Proposed Building Heights Amendment – Submissions Received

***Cherrywood Planning Scheme
Proposed Amendment No.8
(Building Height and Density Review)***

SDZ Planning Scheme Map 2.3

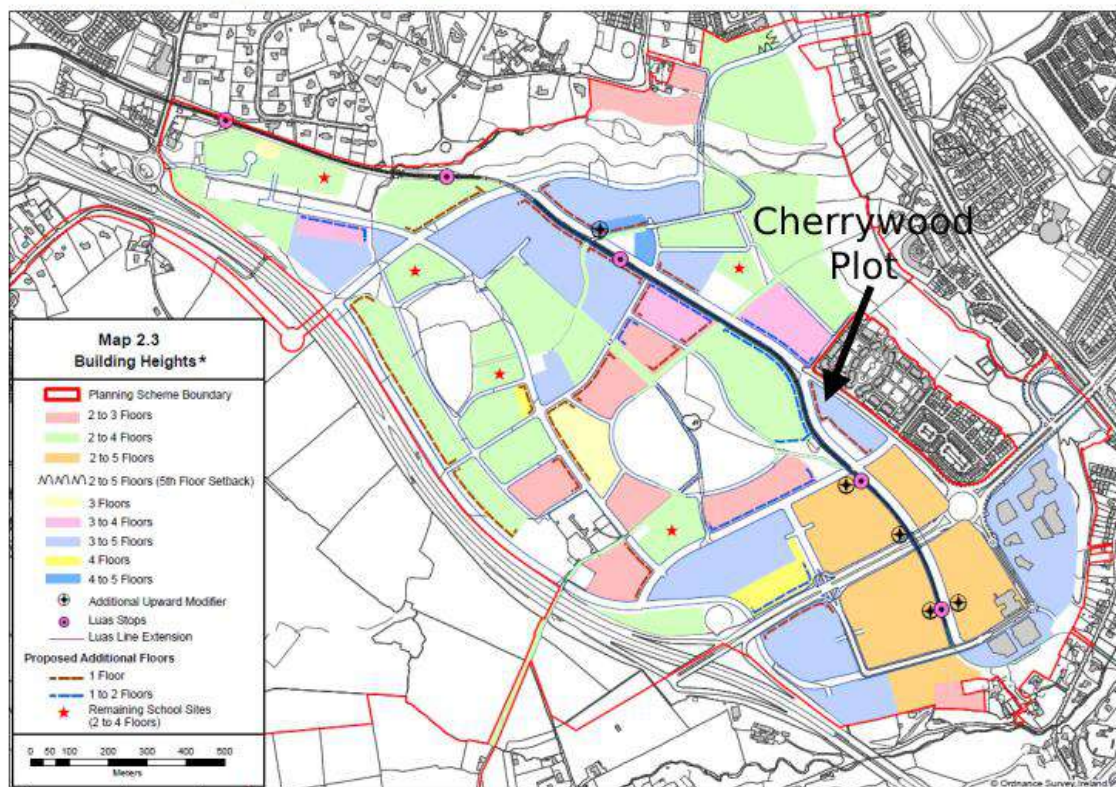
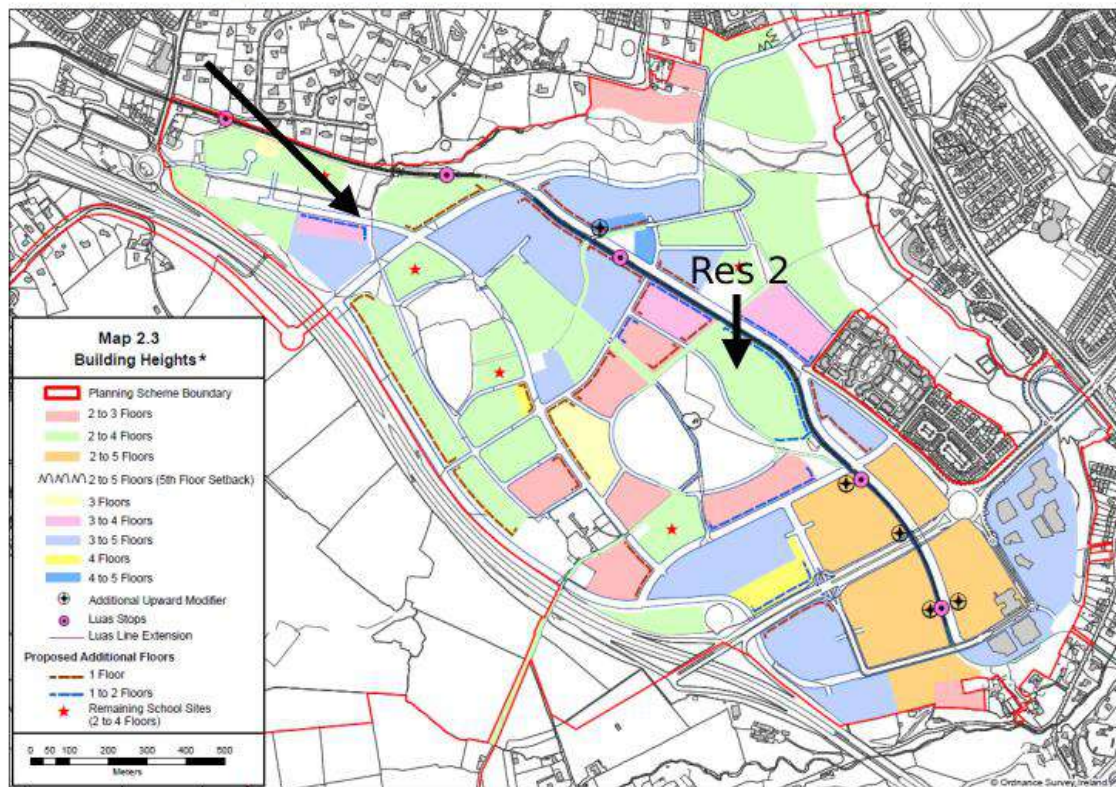
The proposed Amendments seek to add an additional 1 to 2 storeys along Grand Parade, creating a consistent corridor height of 6-storeys.

In compliance with the objectives of the Guidelines to increase density and create a strong sense of place, the proposed Amendments to building height are welcome insofar as they relate to WNS plots located in Development Area 1 Lehaunstown and Development Area 4 Domville.

Proposed Amended Map 2.3 Building Heights

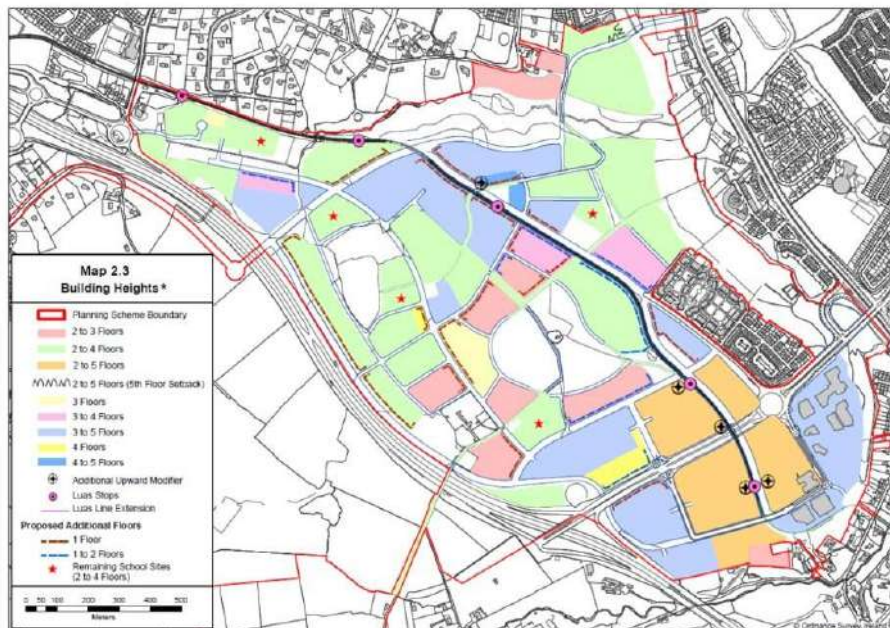
The areas coloured Yellow are focus of this submission.
